# Access Compliance Report

## Public Rights-of-Way (Curb Ramps)

| Intersection ID: 21456 | Main Street: REGENT RIDGE LN | Cross Street: WITHERS MILL DR | Location:              | E                    |
| ADA ID: A559F8B81A3B   | Ramp Type: Directional1      | Initial Pass/Fail: Fail       | Overall Compliance: No | Severity Score: 12.5 |

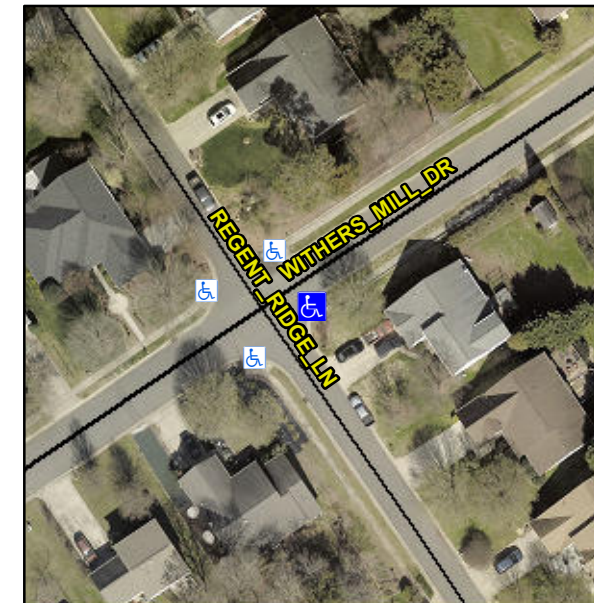
**R304.5.3**

| Compliance | Description           | Data  | Compliance | Description                 | Data |
|------------|-----------------------|-------|------------|-----------------------------|------|
| No         | Ramp XSlope (%)       | 6.2   |            |                             |      |

**Remove & Replace Entire Ramp.**
